MEMORANDUM

Re: 440 Old San Carlos Blvd – REZ2013-0001, SEZ2013-0005, VAR2013-0006

RE: REZ2013-0001; SEZ2013-0005; and Variances - Houseboat
(formerly Matanzas CPD)

EXHIBIT A
MATANZAS
REDUCED BUFFER EXHIBIT

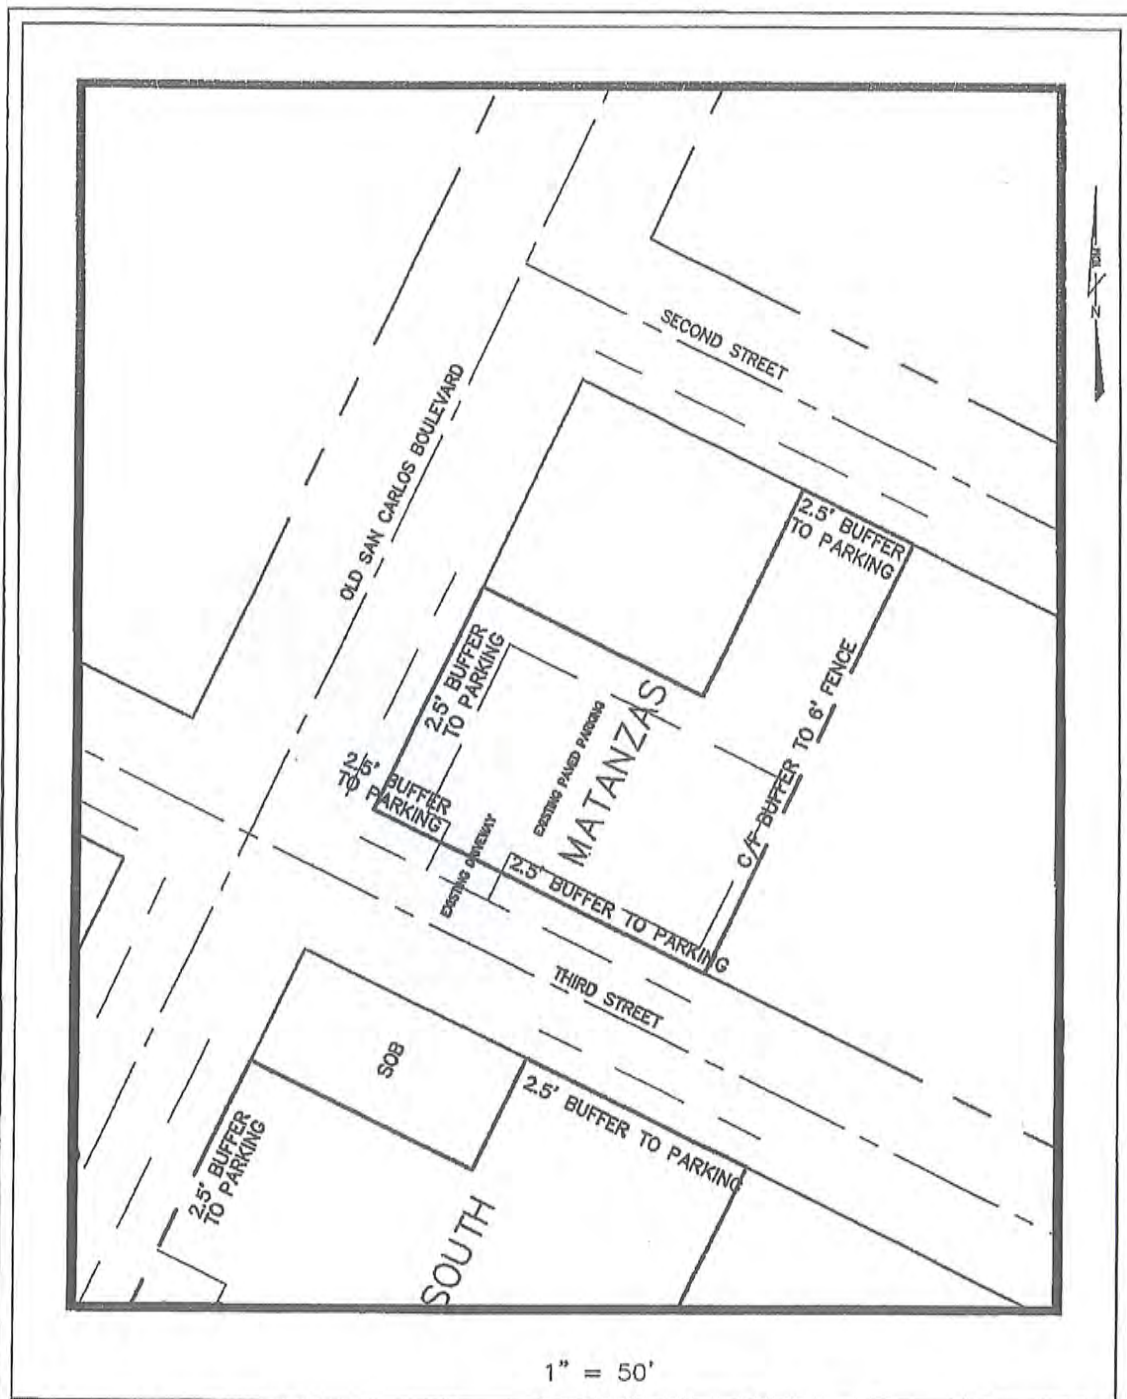
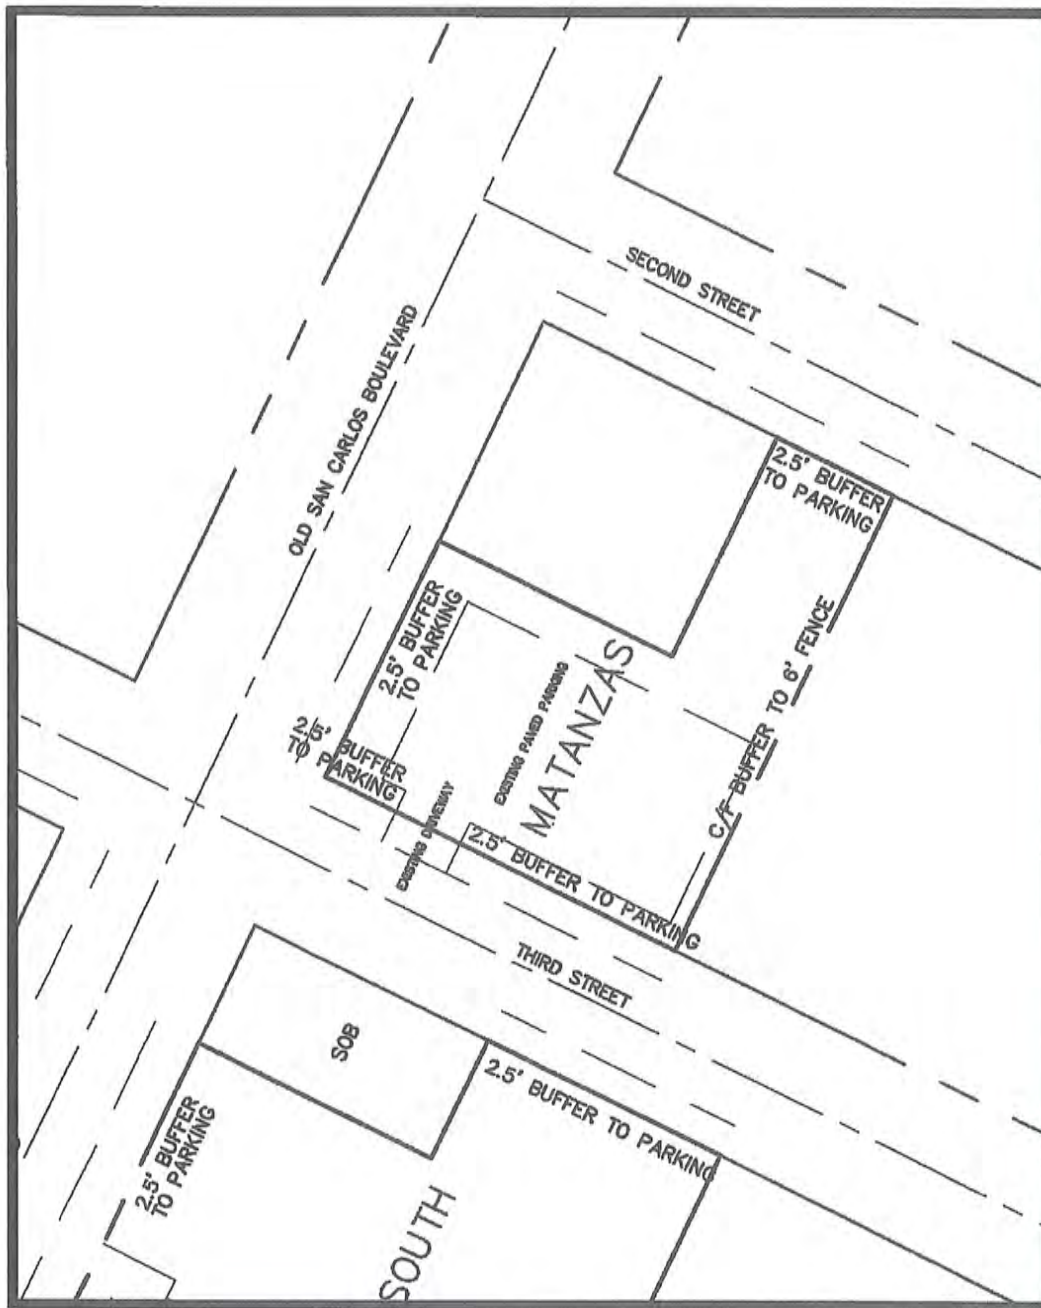
From Staff's estimation, the additional variances numbered 3, 4, and 5 are essentially to allow the existing conditions of the subject property to remain and not be rendered nonconforming by the act of rezoning the property from CPD to DOWNTOWN. Upon initial review, it appears that granting the requests to maintain a status quo condition is a reasonable action. However, one must remember that variance approvals run with the land – meaning that any approvals granted to permit and allow for existing conditions will remain in effect at the time of redevelopment. Furthermore, at the time of redevelopment the Town has its best opportunity to bring those properties inconsistent with the Land Development Code and the Comprehensive Plan into compliance.

Staff does agree with the applicant, however, that the size and scope of the buffers required (15' for a ROW buffer and 15' with a wall or 30' without a wall between the subject property and the adjacent residential use) by these code sections could be considered excessive and inconsistent with the intent of a vibrant, mixed use downtown core area encouraged by the Comprehensive Plan. As stated in the Staff report that was written in preparation for the November LPA hearing, Staff understands that a 15' foot buffer on an existing site not currently under development order may prove to be a burdensome requirement. However, the code does encourage landscape buffers as a way to shield parking lots from view and the pedestrian experience (see also Section 34-2022(c)). Staff would suggest that conditioning an approval to allow for a reduced size and scope of buffering would be a compromise equally agreeable to both the Town and the applicant. Therefore Staff suggests, as an alternative, that instead of a 15' wide buffer, the applicant will install a 5' buffer with the same number of shrubs and trees. This would be consistent with buffer deviations approved at 2301 Estero and similar to the planting requirements from the Seasonal Parking lot provisions.

EXHIBIT A
MATANZAS
PARKING LAYOUT-
JOHN RICHARD
FORT MYERS BEACH, FL
 SOURCE: TDM, 12/13

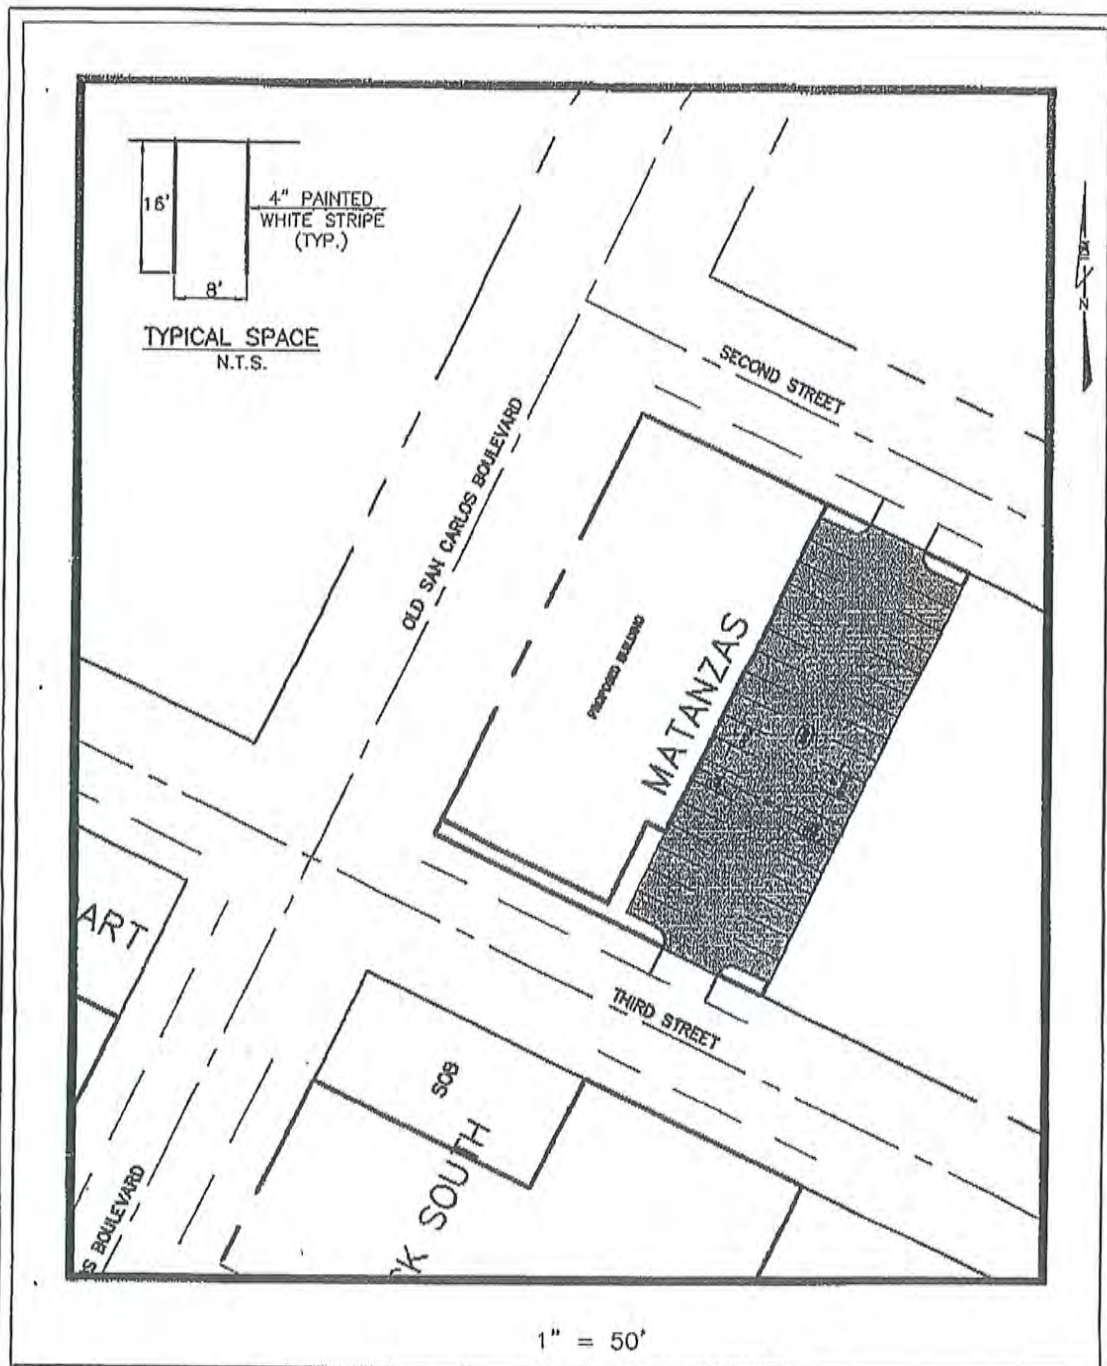
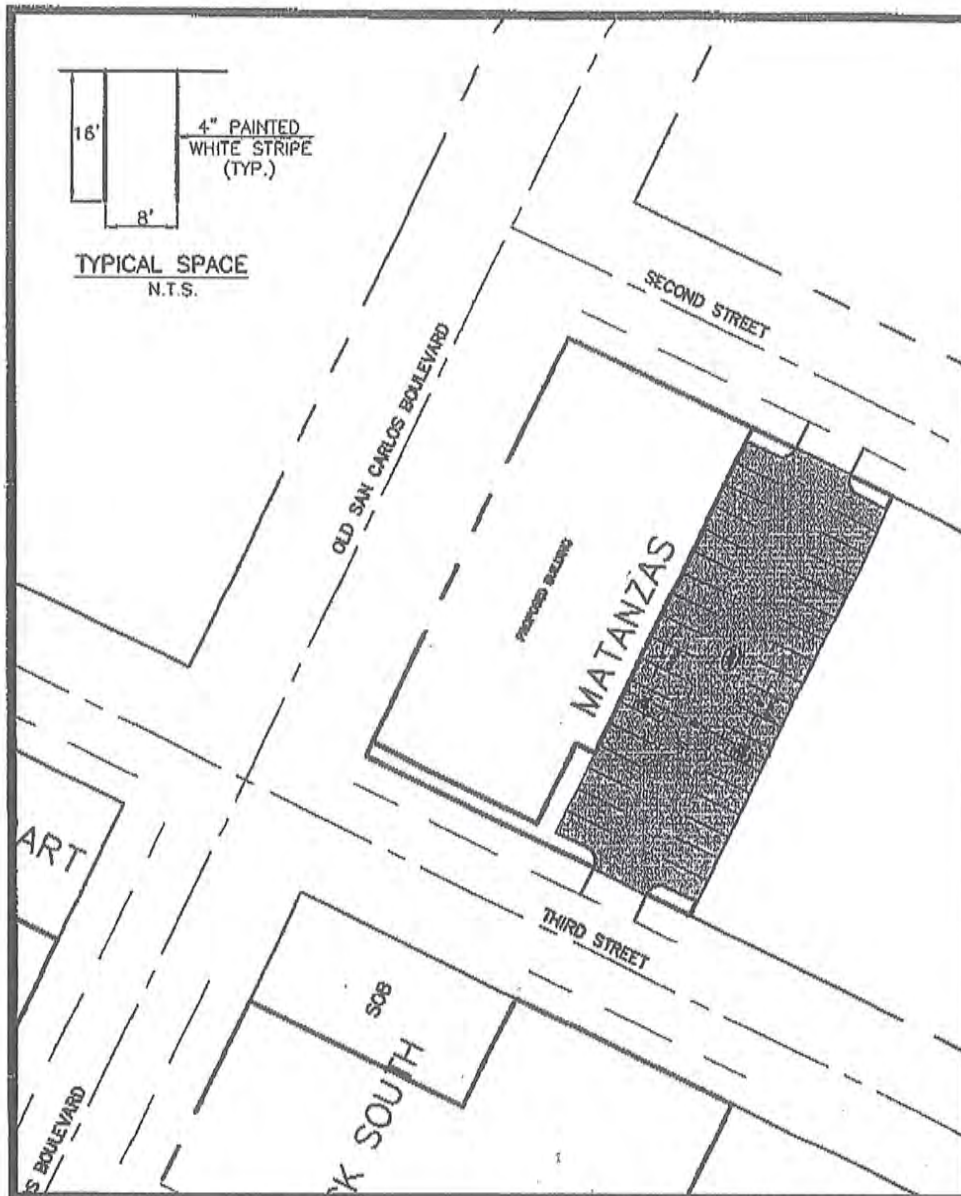
Variance #6 is a request to allow parking space and parking aisle dimensions that are smaller and narrower than code allows. Currently Section 34-2016 defines a minimum parking space as 8.5'x18' or 8.5'x20' and parking aisles between 11' to 22' wide depending on the specific layout of the lot. Similar to the discussion regarding buffers in the previous paragraphs, Staff understands the desire of the property owner to have the existing conditions be considered compliant. The

problem is that when its time to redevelop, the subject property will no longer have to comply with standards that its neighboring properties have been held to, and for what reason? The applicant has not provided any justification for allowing a reduction in parking dimensions. Furthermore, an 8x16 parking space with a one-way drive aisle is a very narrow space to navigate and with the seasonal influx of drivers unfamiliar to the roads and parking lots of the island, Staff is concerned about the safety ramifications of supporting this request.

Staff would propose a compromise on this particular request that the applicant utilize the dimensions laid out in request #6 until the time of redevelopment, at which time they would be required to install a new parking lot that meets buffer requirements and parking lot dimensions set forth in Sec. 34-2016.

EXHIBIT 1
MATANZAS
SITE VISIBILITY TRIANGLE EXHIBIT
 JOHN RICHARD
 FORT MYERS BEACH, FL
 SOURCE: TDM, 12/13

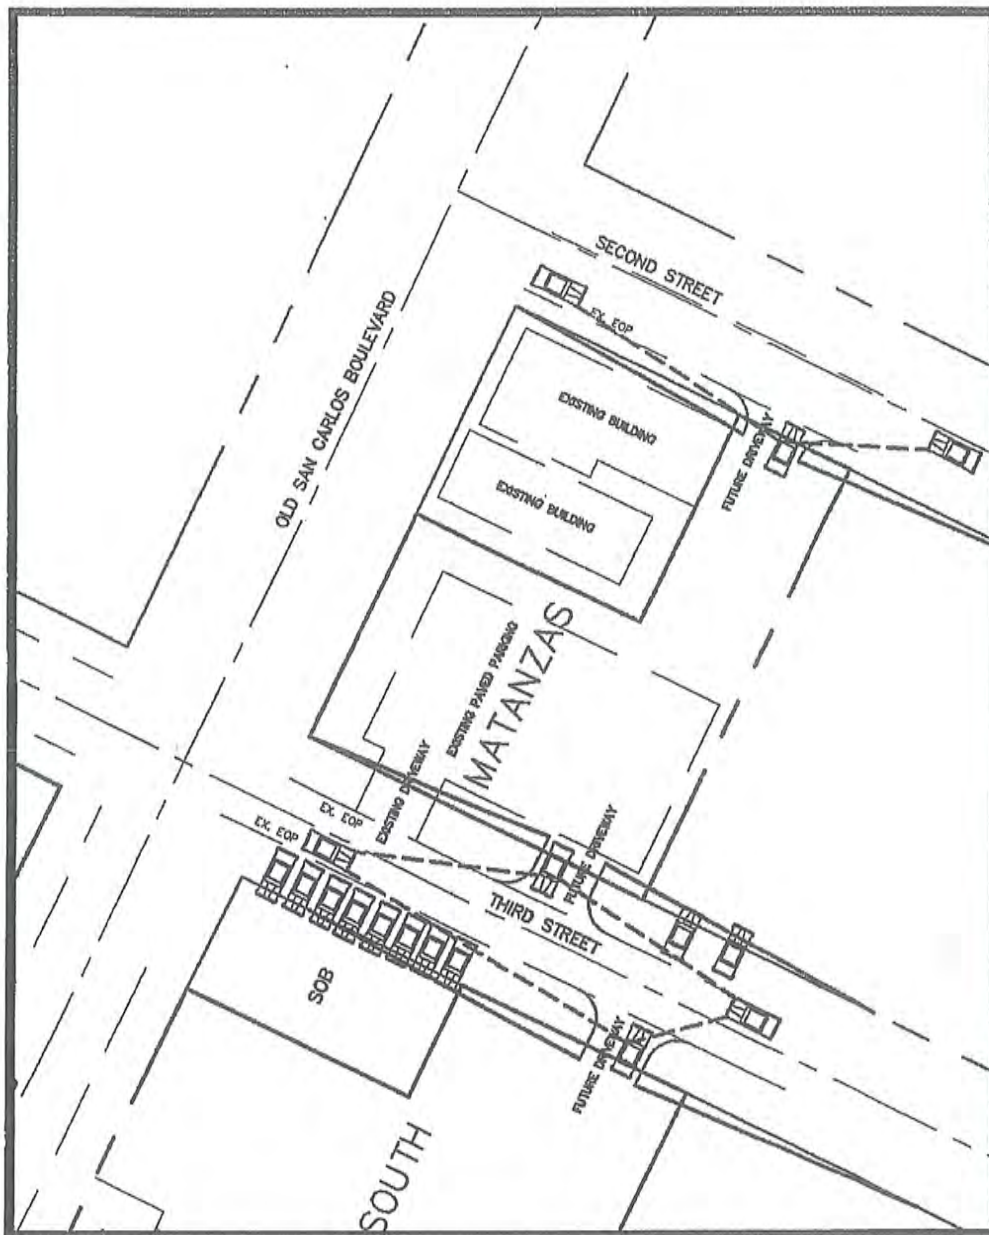
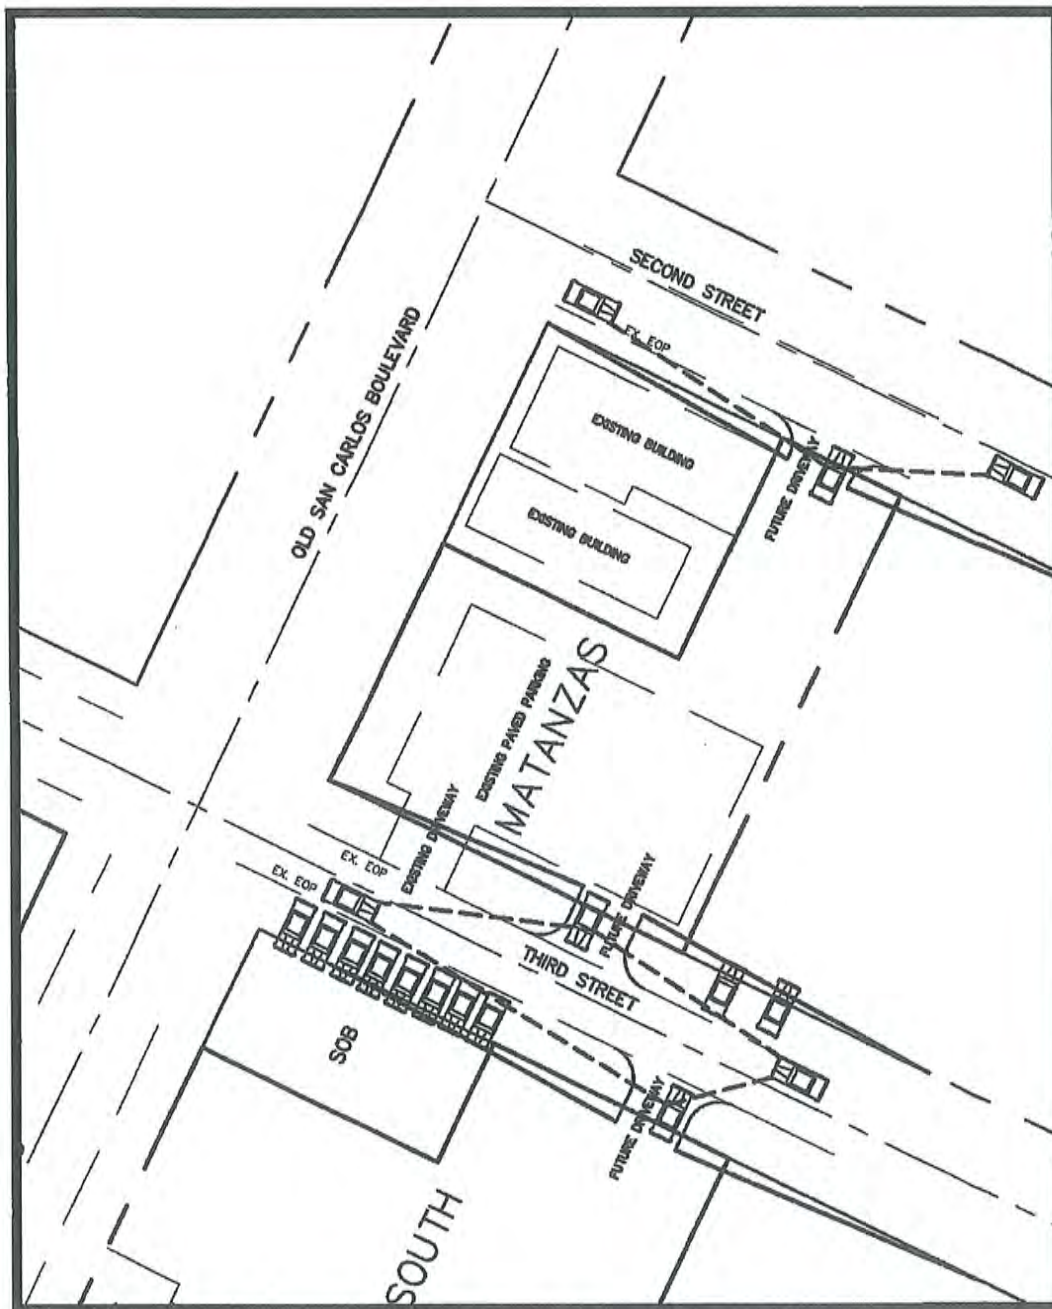
The final request is to allow relief from the visibility triangle requirements as set forth in Sec. 34-622(b) and Sec. 34-3131. The applicant refers to a sketch provided with material for both this case and another so it was unclear as to what the intent of each document was. And once again, no justification was submitted with this request, so Staff was unable to provide an analysis. Therefore Staff must recommend denial of the request.

APPROVAL WITH CONDITIONS
7. Section 34-622 (b) and 34-3131 from visibility triangle for Second and Third Streets to allow reduced triangle as set forth in sketch - **DENIAL**
